**ALBERTA TRANSPORTATION
SPRINGBANK OFF-STREAM RESERVOIR
PROJECT
Response to NRCB and AEP
Supplemental Information Request 2,
dated November 18, 2019**

Prepared for:
Alberta Transportation

Prepared by:
Stantec Consulting Ltd.

April 2020

Sources: Base Data - Government of Alberta, Government of Canada. Thematic Data - Stantec Ltd.

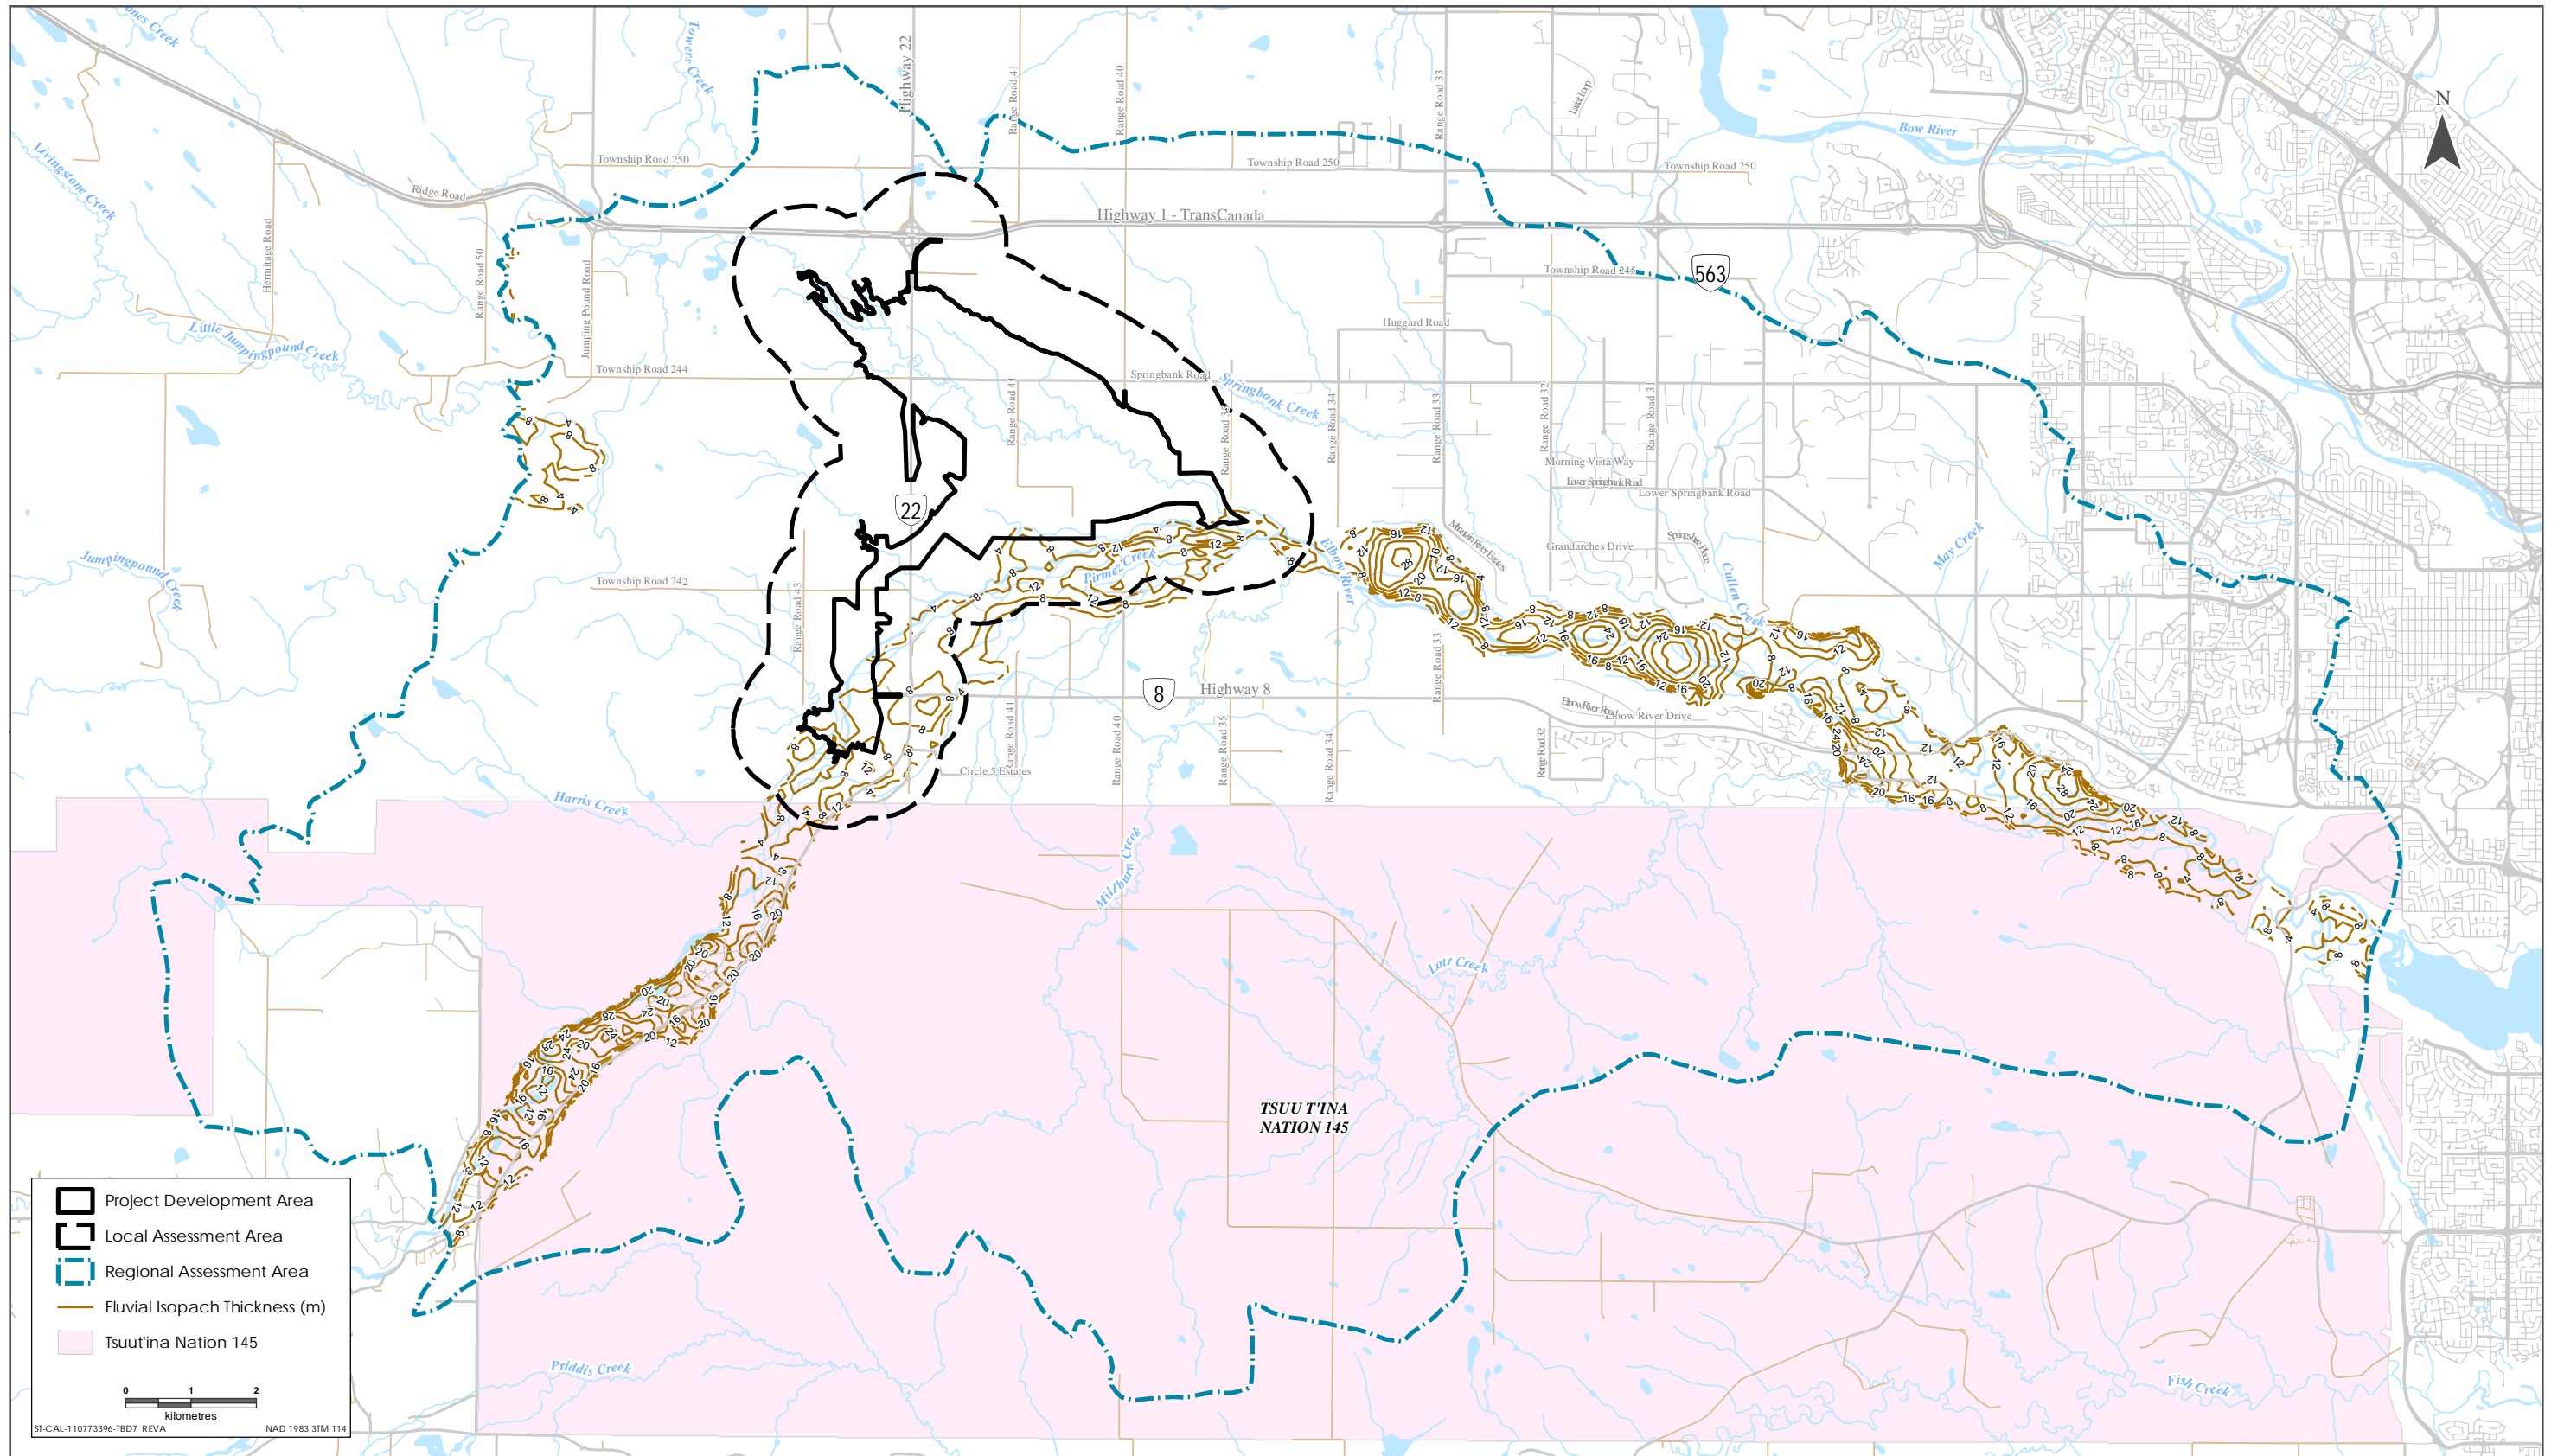
Figures 3-8, 3-10 and 3-12 in Appendix IR42-1 show isopach maps for glacial till, glaciolacustrine, and recent fluvial deposits. Contour labels are not shown for all areas in the expanded RAA and it is not obvious what they are.

- a. Provide the missing labels for the isopach contours in the expanded RAA.**

- a. The contour labels in Alberta Transportation's response to Round 1 Natural Resources Conservation Board (NRCB) information request (IR)42-1, Appendix IR42-1, Figures 3-8, 3-10 and 3-12 have been revised in the following figures: Figure 5-1, Figure 5-2, and Figure 5-3.

Figure 7-1. MW16-15-34 Groundwater Elevation

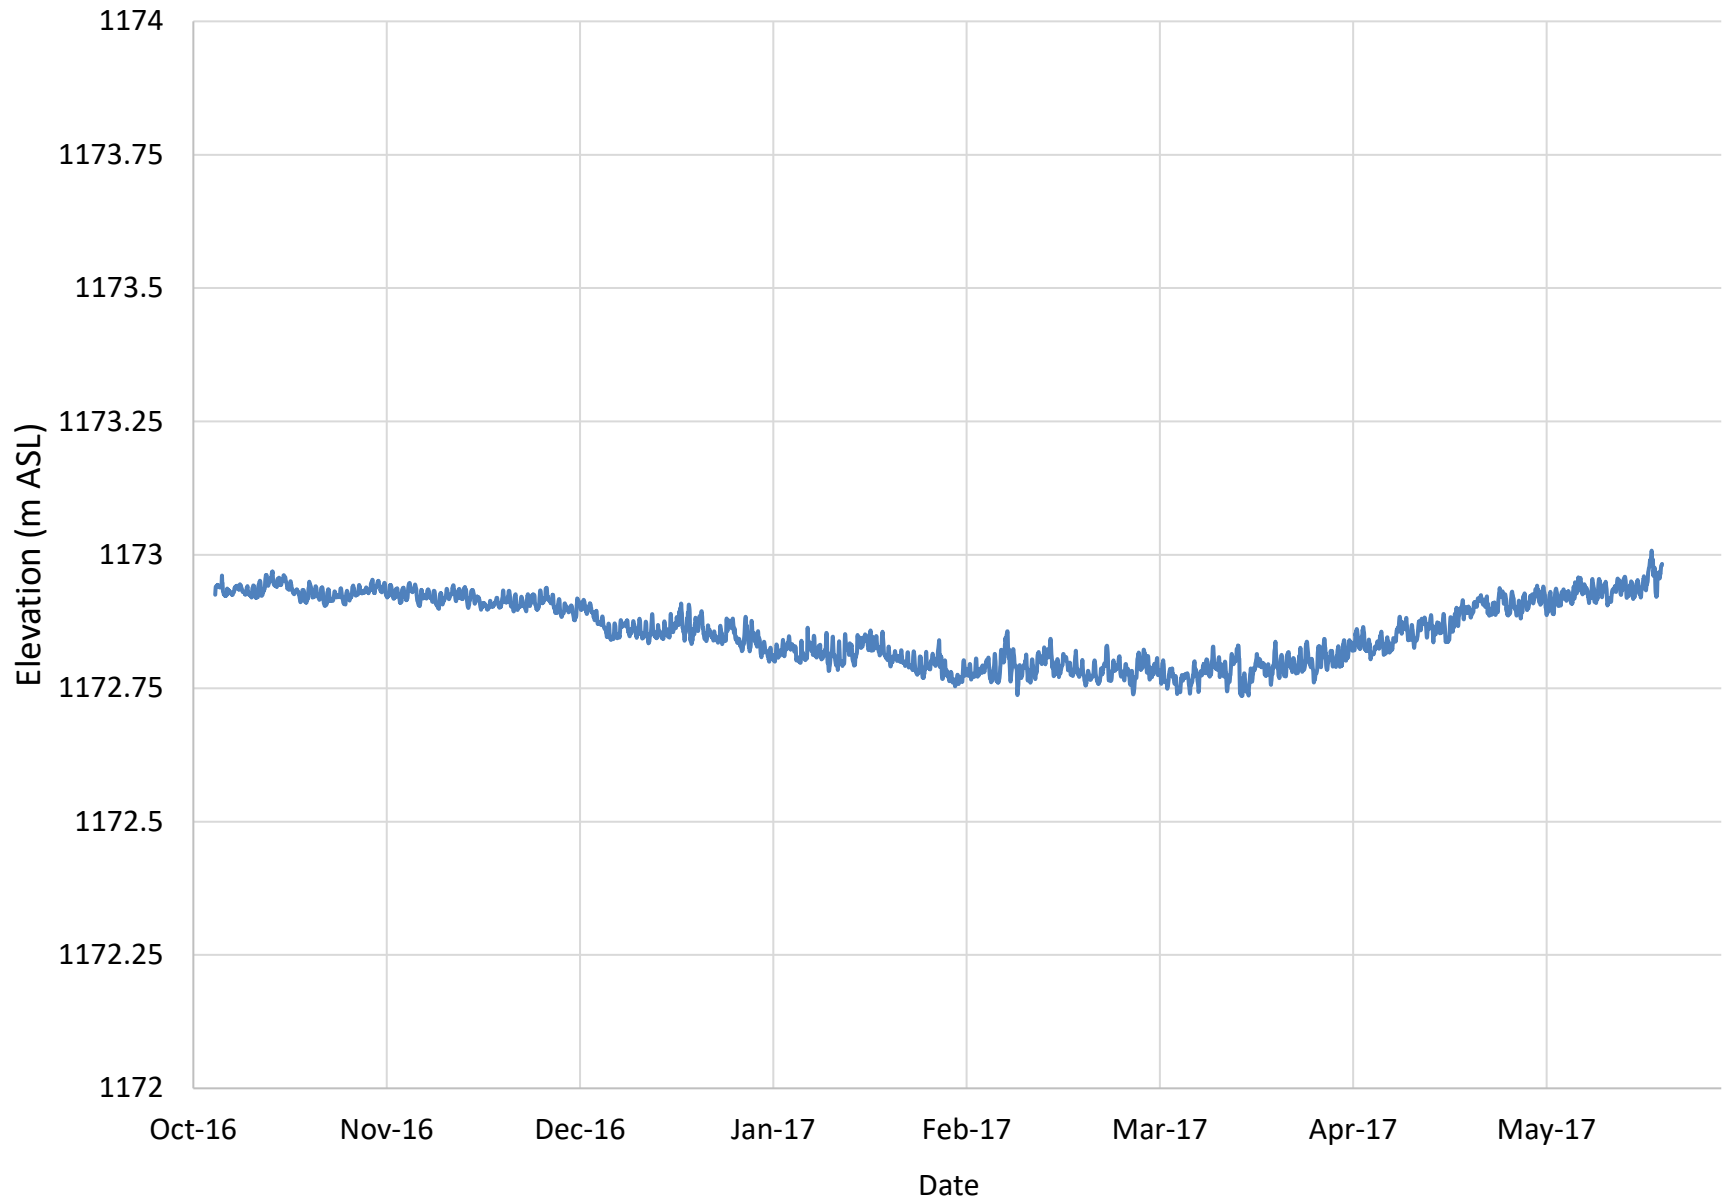
The hydrograph for monitoring well MW16-8-19 is repeated several times in Figure 3-26. Table 2-1 shows that pressure transducers were installed in MW16-15-34, MW16-7-5 and MW16-18-6 and these are not shown in the referenced figures. Figure 3-24 includes a hydrograph for monitoring well MW16-17-5, however Table 2-1 shows that no pressure transducer was installed.

- a. Provide the hydrographs of monitoring wells MW16-15-34, MW16-7-5 and MW16-18-6. In addition, clarify whether a pressure transducer was installed at MW16-17-5. If no transducer was installed at MW16-17-5 then correct and update the document.

The hydrograph for MW16-8-19 appears in Figure 3-25 and Figure 3-26 multiple times as an error and, as a result, the hydrographs for MW16-15-34 and MW16-18-10 were not included. These two hydrographs are provided in Figure 7-1 and Figure 7-2.

Figure 8-1 Estimated Change in Hydraulic Head at the Edge of the Reservoir using an Analytical Solution (Aquifer $K = 1.4E-06$ m/s)

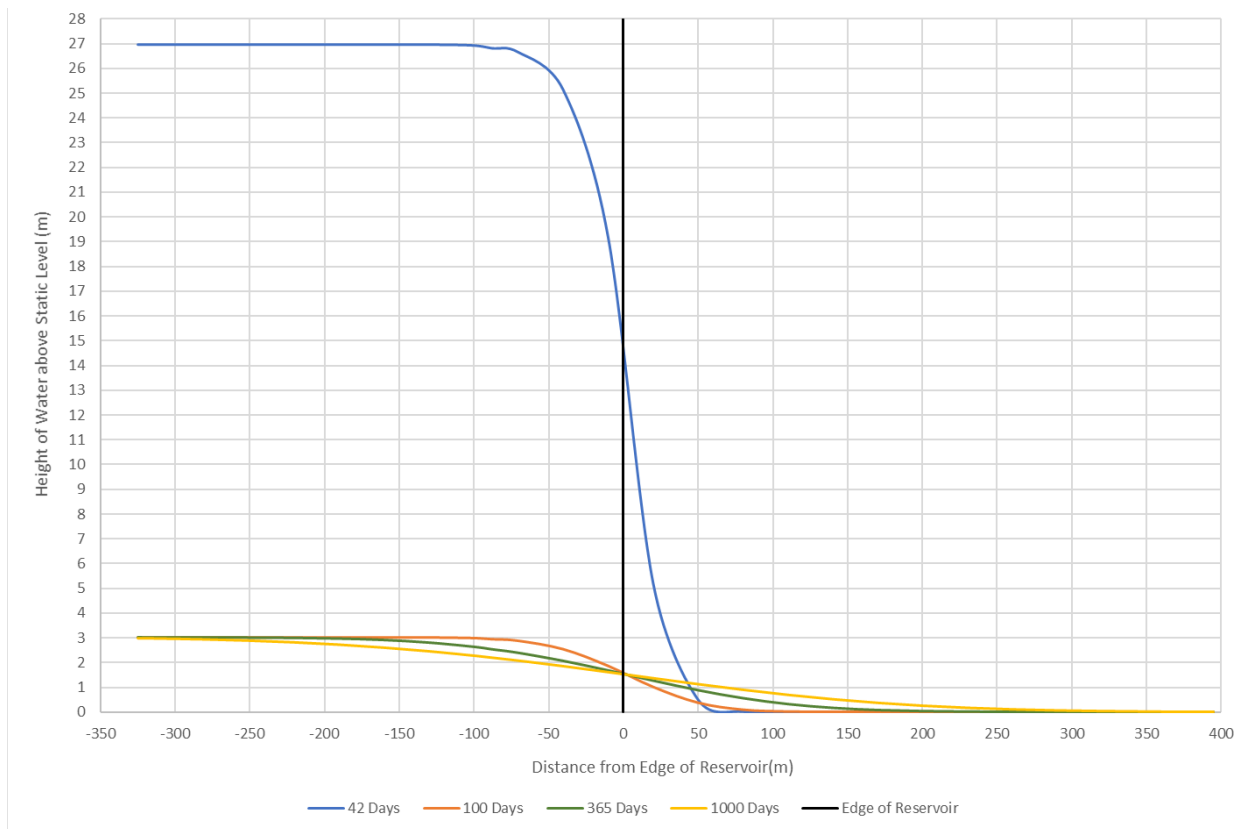
Appendix IR42-1, Section 5 summarizes the predicted effects of the project on water levels. Appendix IR42-1, Figure 5-13 displays simulated head increase up to 24m in the reservoir, yet after timestep 650 there is less than 0.5m of head increase adjacent to the reservoir.

- a. Confirm the elapsed time associated with timestep 650.
- b. Discuss why is there no propagation of drawdown away from the reservoir in Figure 5- 13. Comment on whether the lack of drawdown has been validated by approximating the problem with an analytical solution.
- c. Discuss whether the settings that control the behavior of the phreatic surface are adversely affecting the simulated response to flooding.

Figure 8-1 presents an idealized cross-section through the edge of the reservoir area showing the change in hydraulic head over space and time using the calibrated hydraulic conductivity (derived from the numerical groundwater flow model) of the upper bedrock aquifer ($1.4E-6\text{m/s}$).

Figure 8-1 shows that the analytical solution predicts that increases in groundwater levels greater than 0.5 m are limited to distances of approximately 150 m beyond the edge of the reservoir. The analytical solution, therefore, supports the limited propagation of effects similarly predicted in the numerical modelling results: in both the numerical model and the analytical solution, the effects of water level increases are limited to within the local area.
